# Evaluation of ITER Upper Visible/IR Camera Design and Performance

Presented at the 2007 ITPA Topical Group Meeting on Diagnostics  
at Princeton Plasma Physics Laboratory

March 26, 2007

## Evaluation of specifications

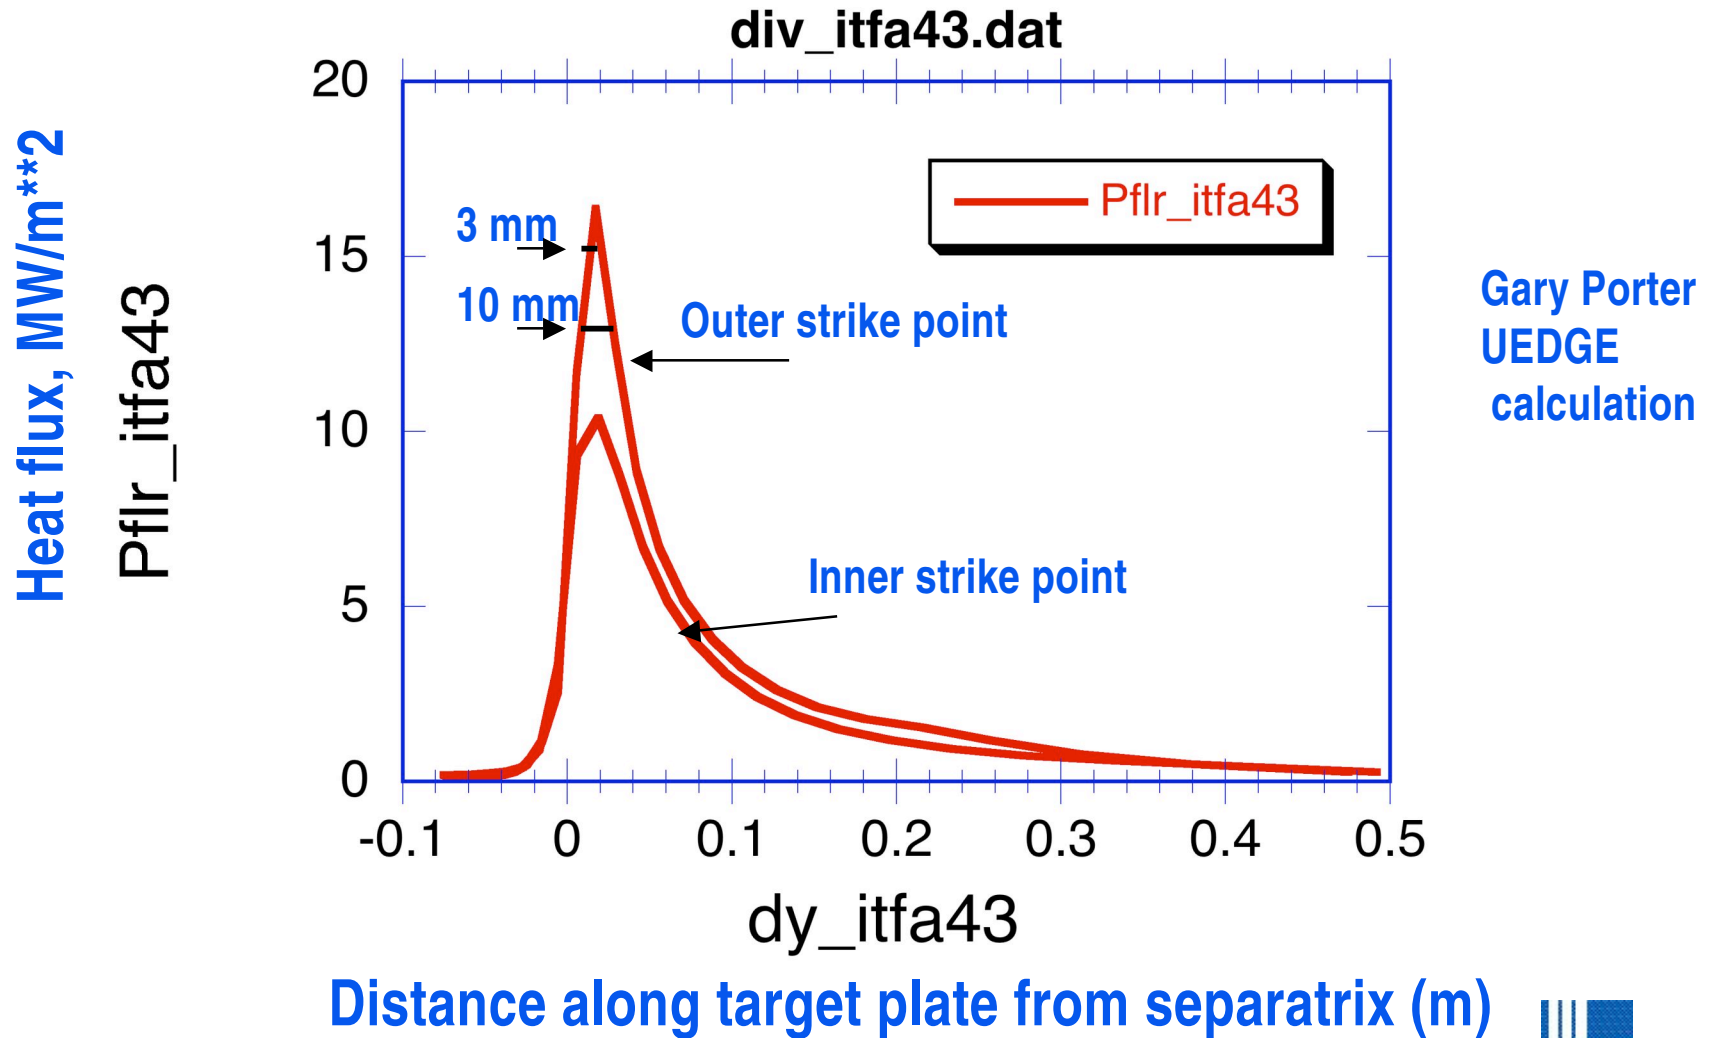
- **Plenty of IR signal for 20  $\mu$ s time resolution**
- **10 ms visible time resolution is enough for vessel protection but not for ELM physics- same 20  $\mu$ s desirable. However, the light levels may not permit this short exposure.**
- **3mm spatial resolution over the whole divertor sounds small, but there is a good reason for 3mm when compared with the width of the heat flux profile peak.**

# Entrance hole size of 10 mm limits IR resolution

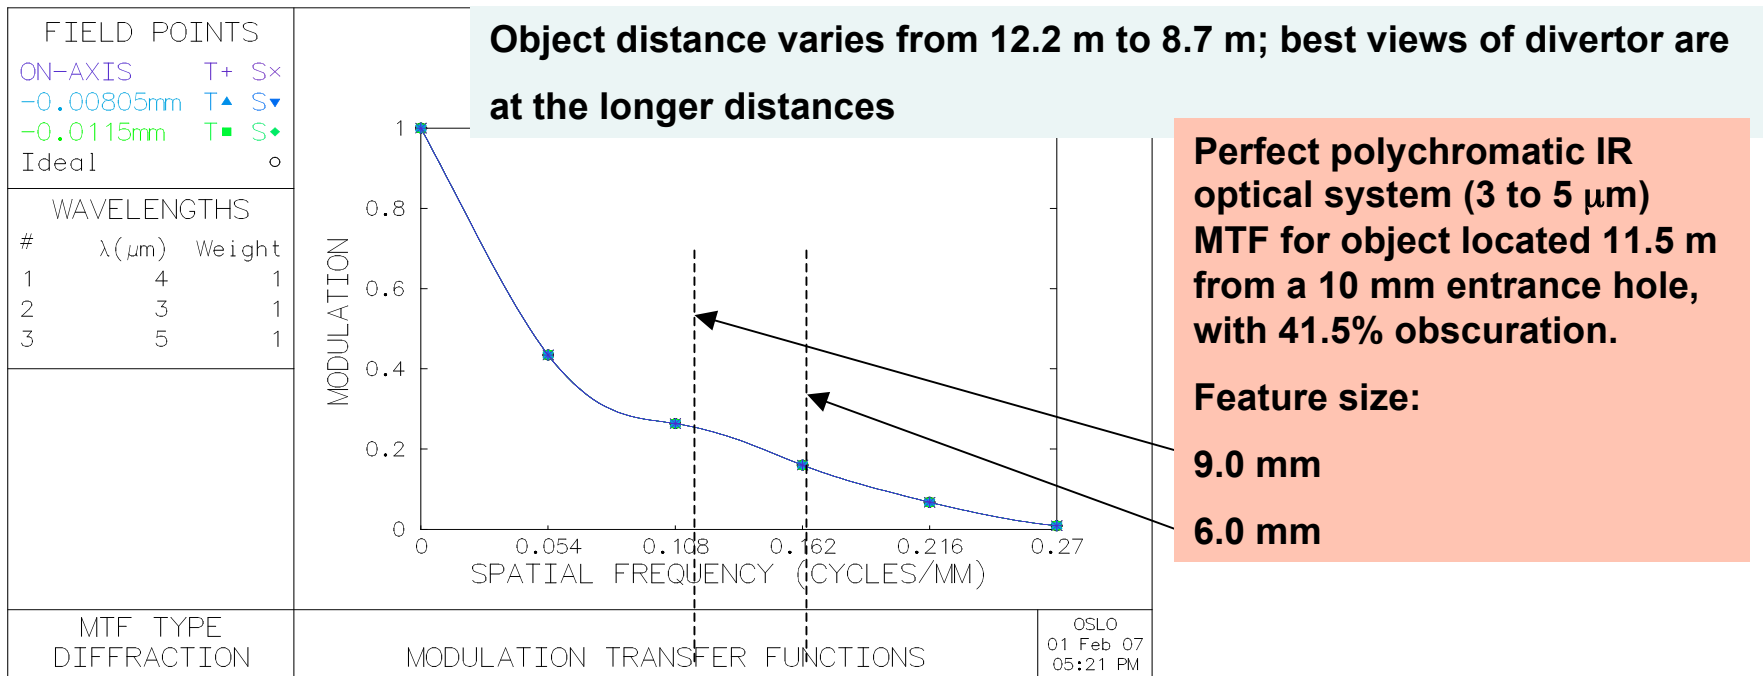
Object distance varies from 12.2 m to 8.7 m; best views of divertor are at the longer distances

# Outstanding issues requiring research/decision/attention

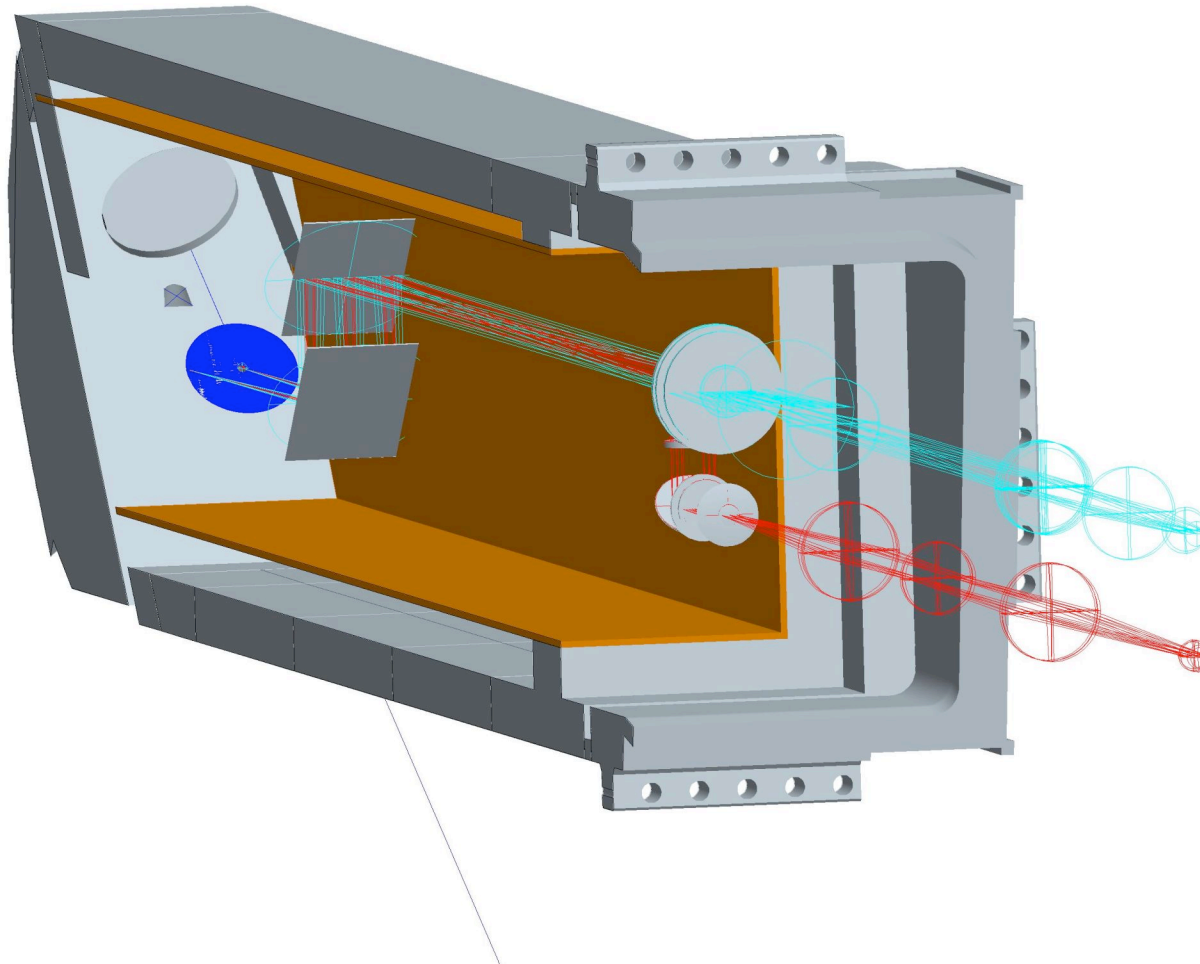
- **A. Large detector for IR, up to 3000-4000 pixels wide, 18-20  $\mu\text{m}$  pixels**
- **B. Large visible detector, 3300 pixels, 4cm long**
- **C. Rejection of microwave power from gyrotrons**

- **D. Acquisition, processing, and storage, and analysis of huge data sets**
- **E. Durability of rhodium-coated mirrors under ion bombardment**
- **F. Durability of visible and IR anti-reflection coatings in high neutron environments**

- **G. Dependence of IR transmission on neutron fluence for ZnSe and Ge**
- **H. Estimate fluorescent emission from optics**
- **I. Develop scheme for calibration of the visible system (if needed)**

- **J. Decide to give up spatial coverage, spatial resolution, or some of both- possibly one system with localized high-resolution coverage- decide on an optical design**

- **K. test/develop reliable vacuum sealing for large ZnSe windows**
- **Items in red before construction of visible/IR camera diagnostic**
- **Items I, J, possibly K before mechanical design**

# 20 mm aperture design has large optics

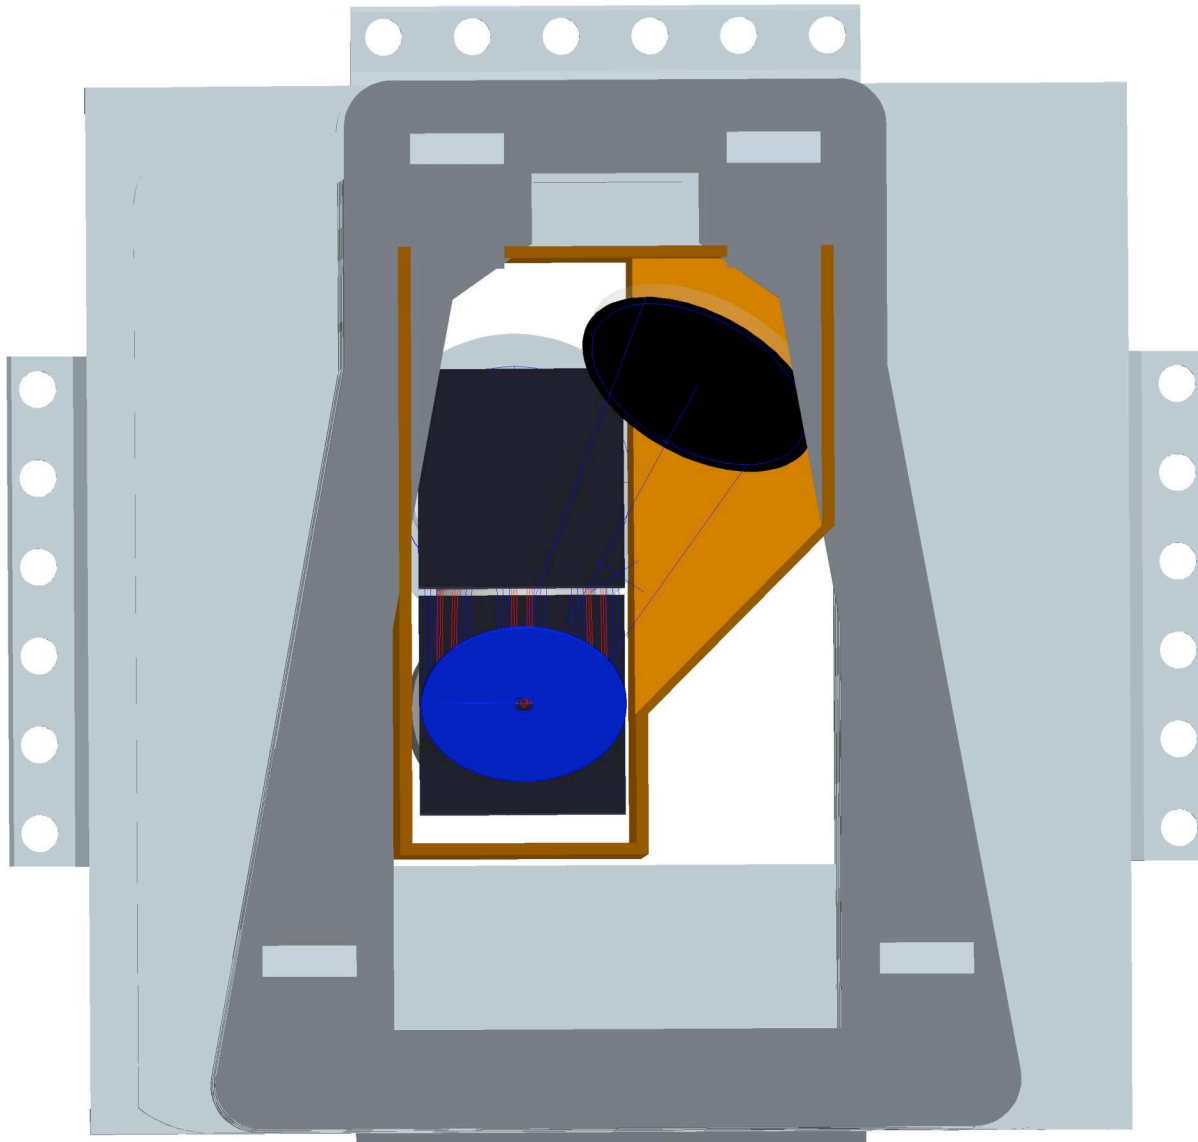
**20 mm aperture design takes up a lot of the port plug**
